Trax (WEM-200) series & Pilot parts Assembly update and FCC assessment

Development Centre Sensors

Issue date: /02/2022

New design

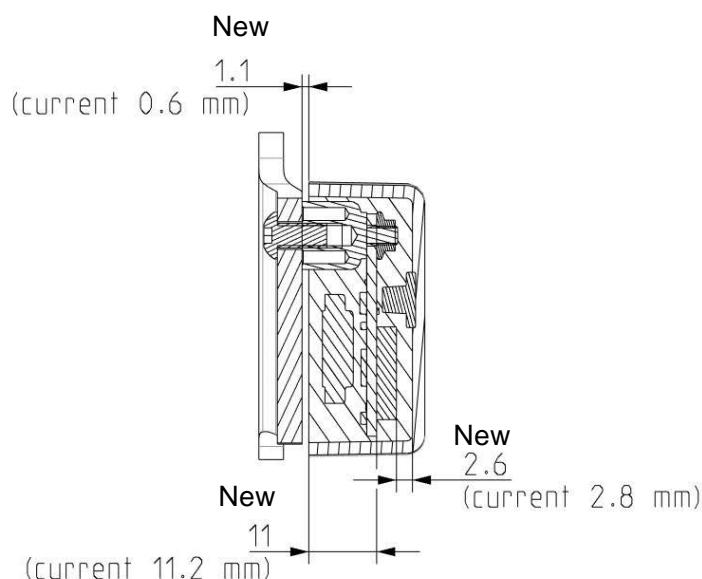
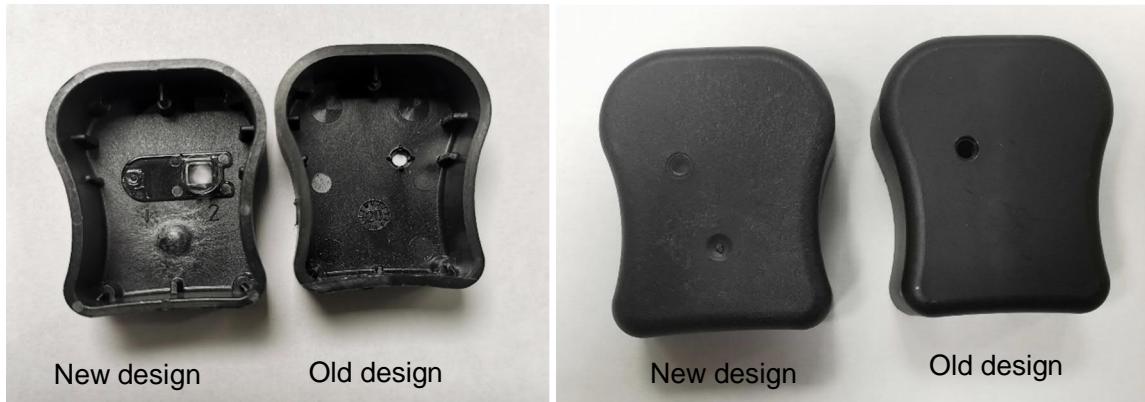
Trax sensor (WEM-200) has been validated in 2019 at 7layers, Series production are planned for this summer 2021. During this industrialization phase we need to optimize some dimensions, to ensure better mechanical assembly, and change the battery reference for the former one is obsolete.

This request is also valid for pilot parts that have the same changes except for the algorithm.
none of the RF functions has been changed, as well as the PCB assembly.

The new battery is PANASONIC CR2540A/GBN

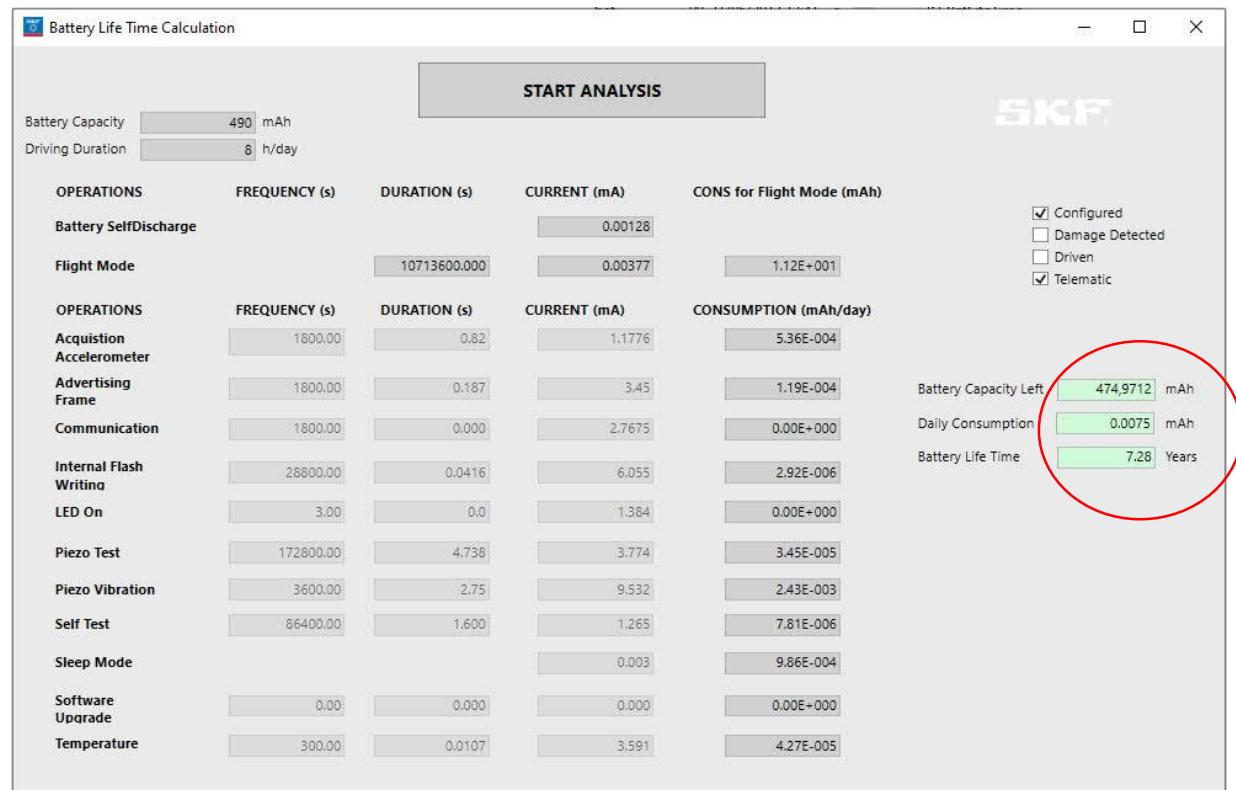
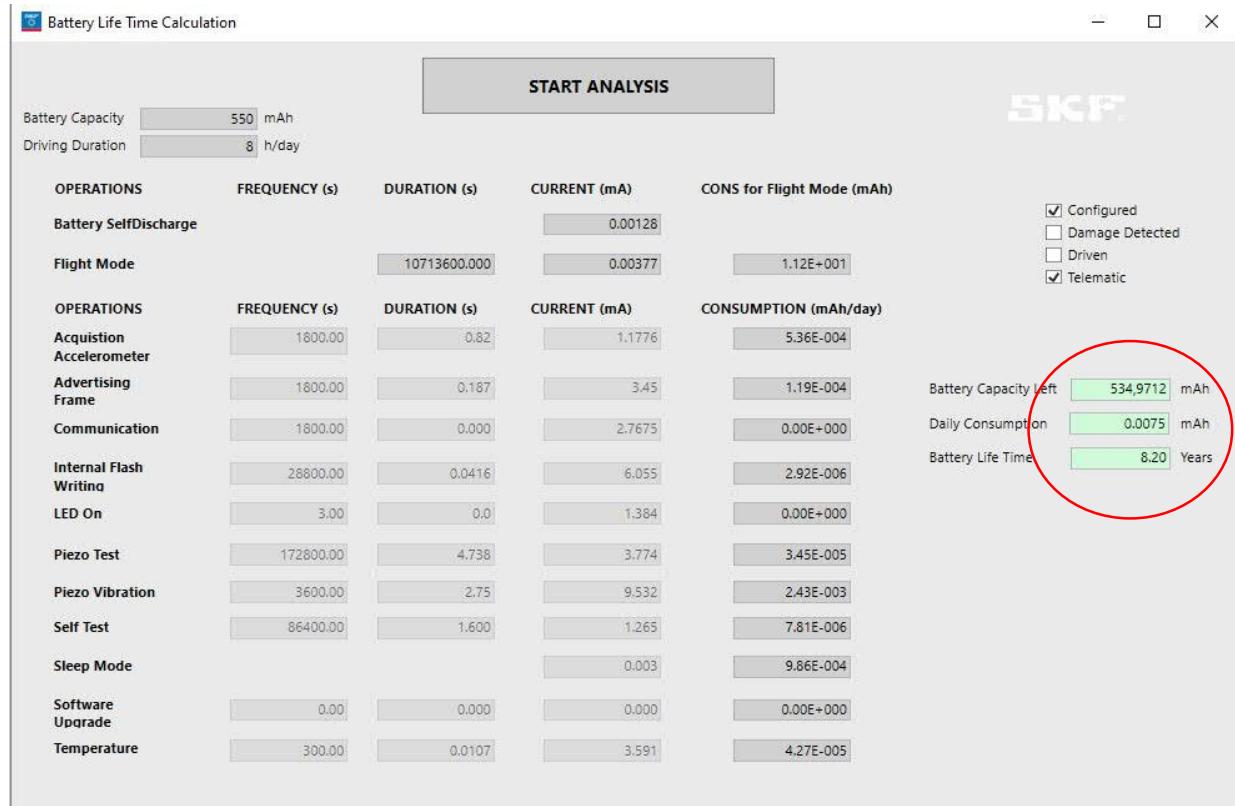
The current battery is RENATA CR2450HTRH-LF:

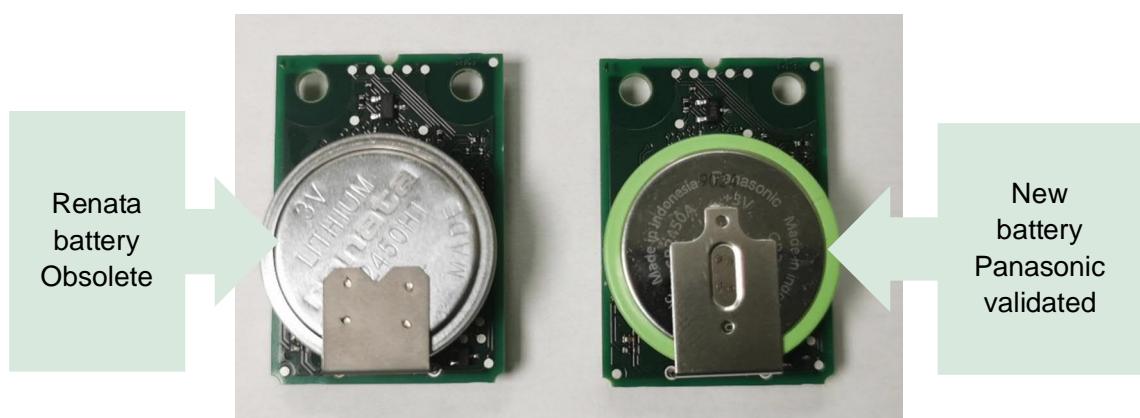
The impact of the battery replacement is on the product lifetime as shown in the table above the battery lifetime evolves from 7.28 years to 8.2 years and this is the only impact on the whole product.

5 Antenna Gain

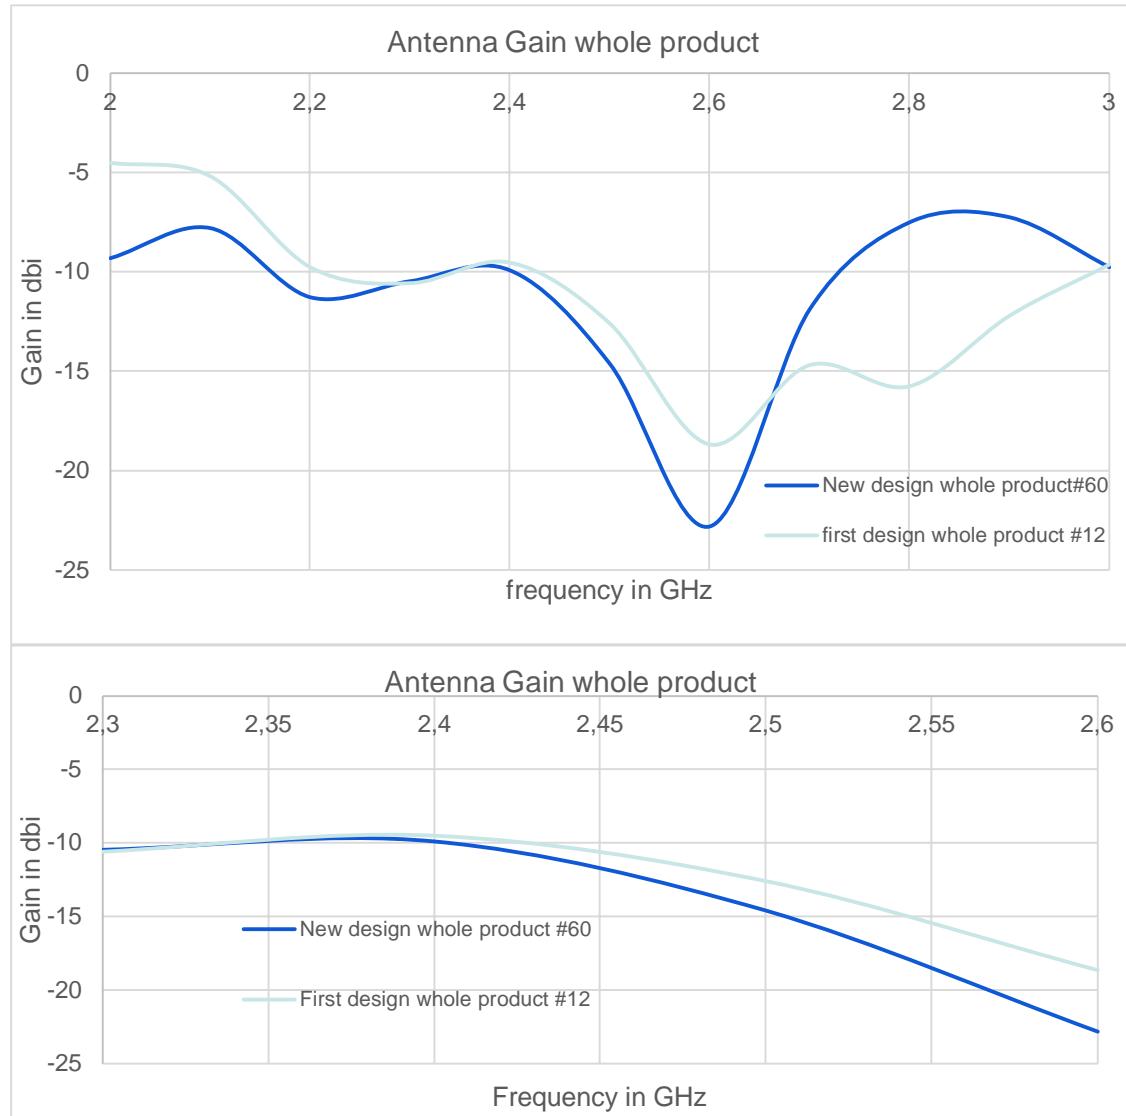
The gain of the antenna on the whole product has been measured for comparison between the old and the new design.

The measurement of the antenna gain on old and new design are similar within the band 2.4Ghz and 2.485Ghz. No difference seen so far due to mechanical changes
